**COMMENTS OF CITIZENS ACTION COALITION OF INDIANA, EARTHJUSTICE,  
INDIANA DISTRIBUTED ENERGY ALLIANCE, AND SIERRA CLUB**

**INTRODUCTION**

**Difference Between IPL Phase II Goal & 2015-17 Action Plan (Annual GWh)<sup>32</sup>**

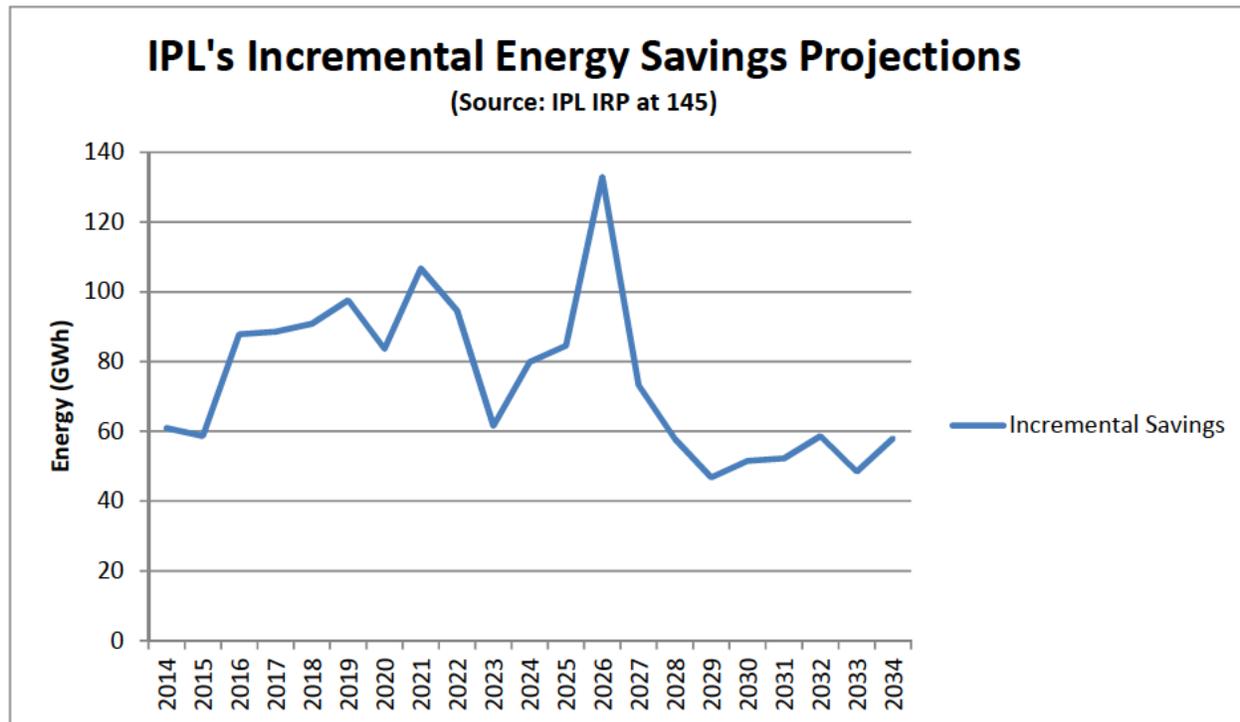
IPL updated its short-term efficiency plan after SEA 340 was enacted. The result is substantially lower savings projections. For example, as a result of SEA 340's opt out provision, IPL estimated that annual savings for the Business Prescriptive program will decrease by 20% as compared to 2014. IPL IRP at 157. IPL notes that a reduction in DSM potential due to the opt outs "may be mitigated to the extent that large customers create energy efficiency projects on their own." IPL IRP at 104. While some of IPL's industrial customers may pursue energy efficiency projects on their own, it is important that IPL incorporate the load impact from such projects in its IRP. Customers who opt out remain part of the interconnection electric system and resource planning should take these customers' load and savings into account.<sup>33</sup>

**Vectren Phase II Goal, Potential Study and IRP DSM Projections  
(Annual GWh)<sup>44</sup>**

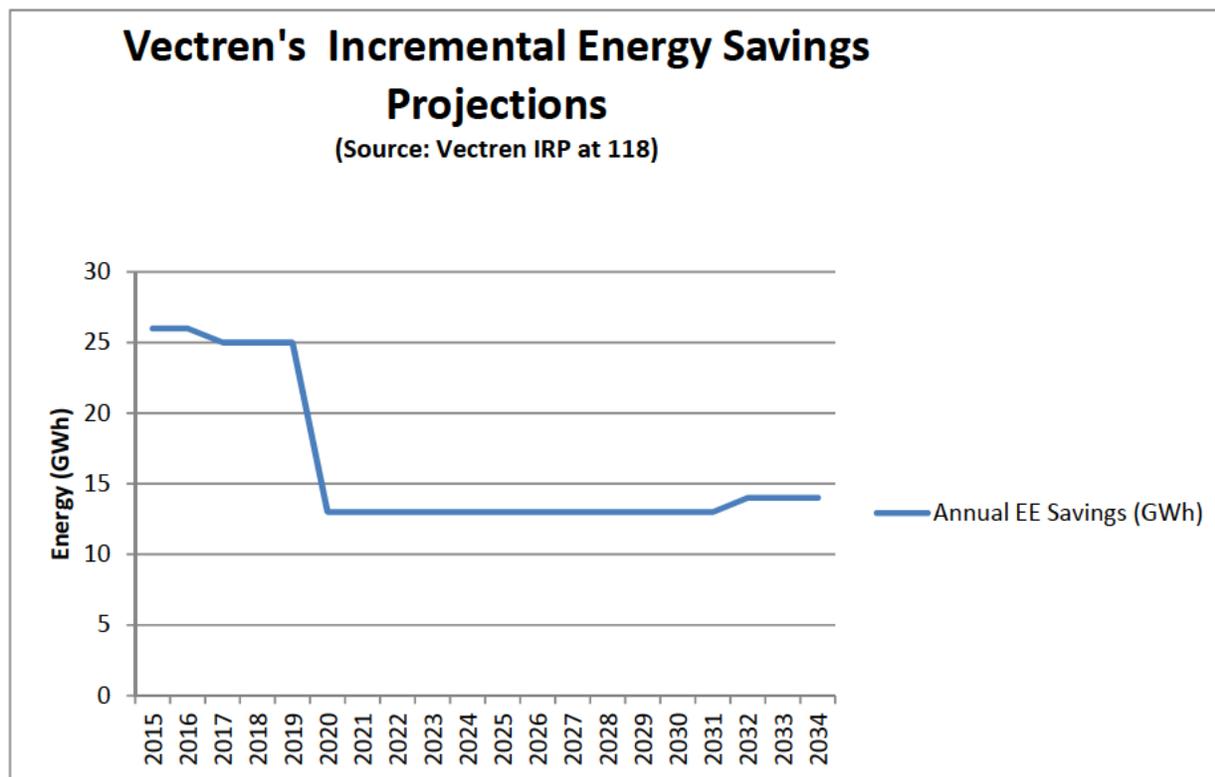
Vectren's IRP projects a sharp decline in the growth of energy efficiency resources over the planning period. Vectren projects 128 GWh of incremental savings over the next five years. Vectren IRP at 118 and Technical Appendix D, Vol. 1 at 8-5. This represents a 72% decrease from the Phase II savings goals and 61% from the potential study recommendations, as the below table shows.

After 2019, Vectren's annual savings drop substantially and then hold fairly steady throughout the planning period, as illustrated below. Vectren IRP at 118. The end result is a cumulative savings projection of roughly 8%, or 480 GWh, by 2034. *Id.* Vectren's declining and then flat annual savings and low cumulative total raises concerns, particularly given the low cost of Vectren's current portfolio, which has a lifetime cost of \$0.03 per kWh. Vectren IRP at 154.

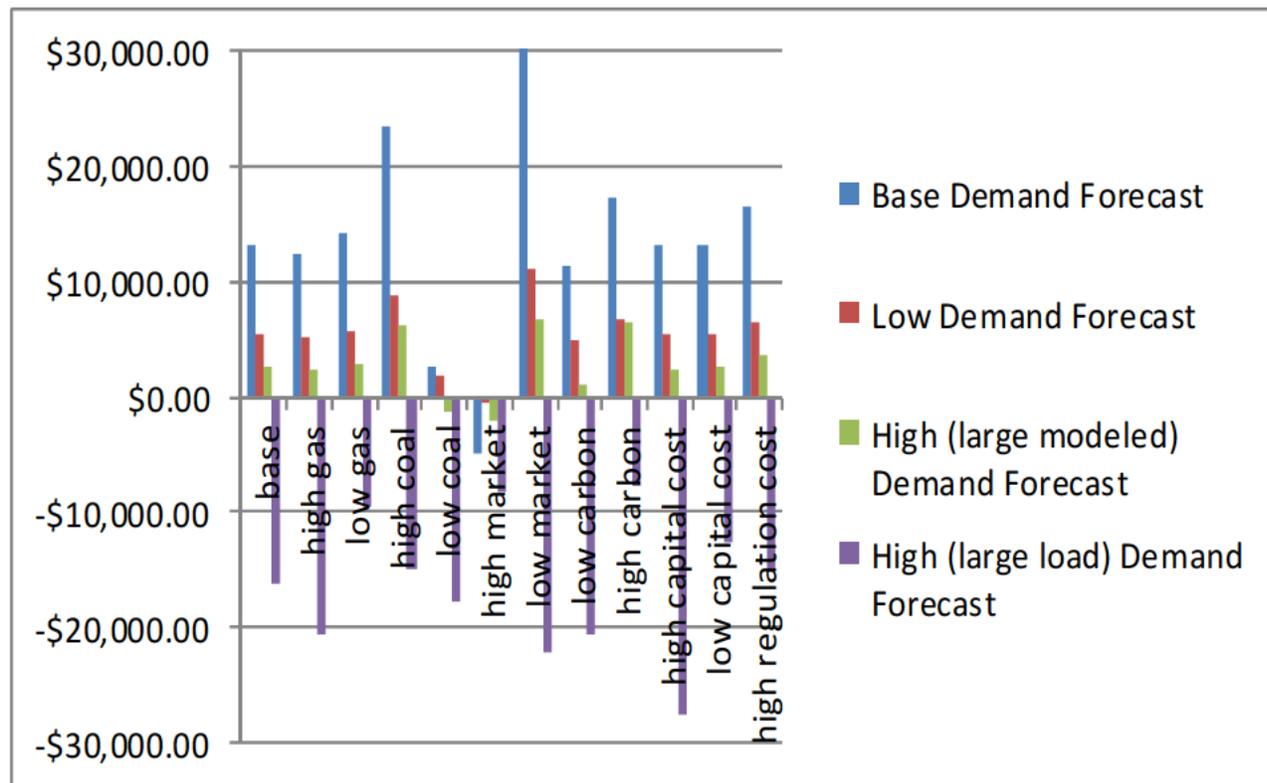
Vectren bases its selection of its preferred resource portfolio in large part on comparing the sensitivity results across the four demand scenarios it modeled. Vectren IRP at 210. For each of the four scenarios, Vectren modeled a base case plus 11 sensitivities, which create 48 unique NPV results. Table 10-14 on page 210 presents the difference in the NPV between the base plan and the plan in which FB Culley 2 is retired in 2020.

Table 10-14 is highly misleading because it implies that for each sensitivity, the low and high demand scenarios are as equally likely to occur as the base demand scenario. This is implausible. The definition of a base forecast is that it is the forecaster's view of the future that is most likely to occur. Vectren should have discounted the three alternative demand scenarios by the likelihood that they will occur. If Vectren had used an appropriate methodology, the data would look completely different.

Below, we provide an example of how the results would have changed if Vectren had discounted the value of each NPV by the probability of the scenario occurring. Since Vectren has not provided probabilities for each scenario and sensitivity, we used a conservative assumption that the base demand scenario is 50% likely to occur and each of the low and high demand scenarios is 16 and 2/3% likely to occur. Vectren could reasonably use different probability than the ones we use, but the alternative scenarios should be less likely to occur than the base scenario, absent some explanation from Vectren. The exact numbers below are not important, because they depend on the probability assigned to each scenario; instead, the relative magnitude of the values is important. In particular, the graph shows that the upside of retiring Culley 2 early is larger than the downside of retiring Culley 2 early in half of the sensitivities.

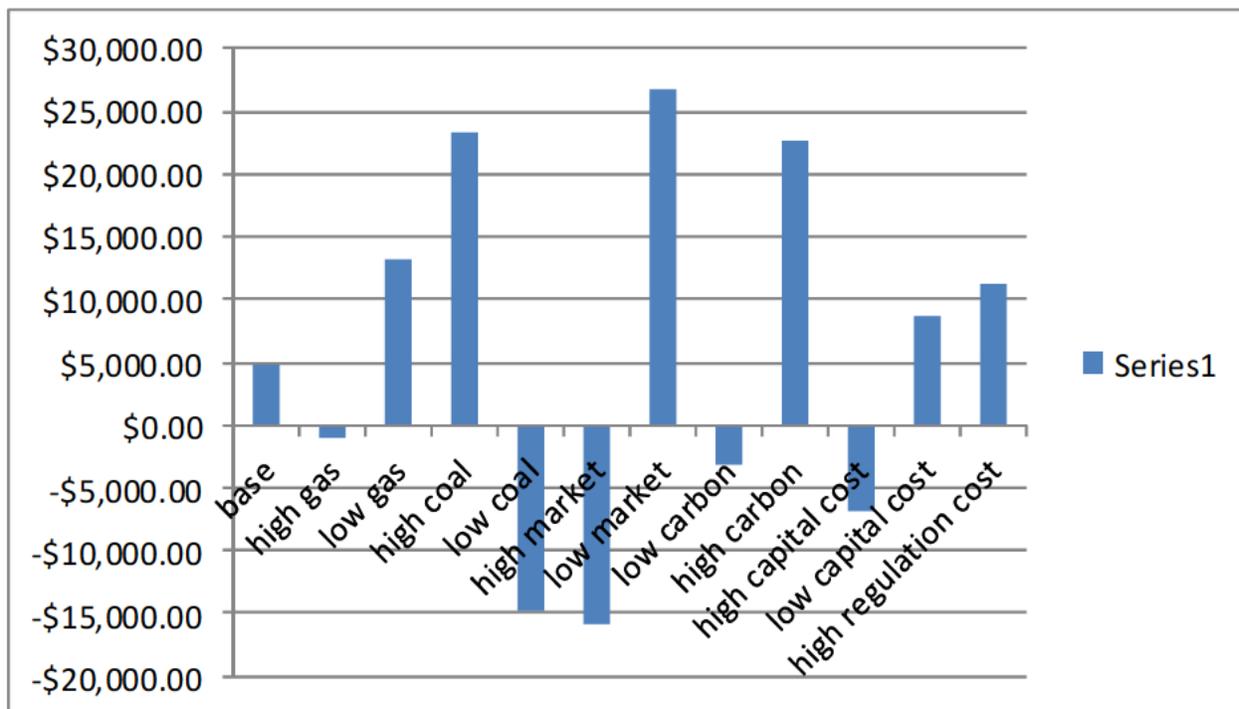
Vectren should have gone one step further and, for each sensitivity, compared the scenarios in which the NPV delta is positive—meaning retiring FB Culley 2 has a lower NPV—to the scenarios in which the NPV delta is negative—meaning retiring FB Culley 2 has a higher NPV. One way to do that is to calculate the expected value of the NPV delta by, for each sensitivity, multiplying the NPV delta by the assigned probability for the demand scenario in question, and then adding the four NPV deltas for each sensitivity. If the overall NPV delta is positive, it means that the benefit of retiring Culley 2 in certain scenarios exceeds the downside of retiring Culley 2 in other scenarios, after considering the probability of each scenario occurring. The graph below followed this methodology to calculate the expected value of the NPV delta, assuming that the base demand scenario is 50% likely to occur and each other demand scenario is 16 and 2/3% likely to occur.

As the figure below shows, in the majority of cases—including the base case—the expected value is positive, meaning that the benefit of retiring FB Culley 2 early is larger than the downside.
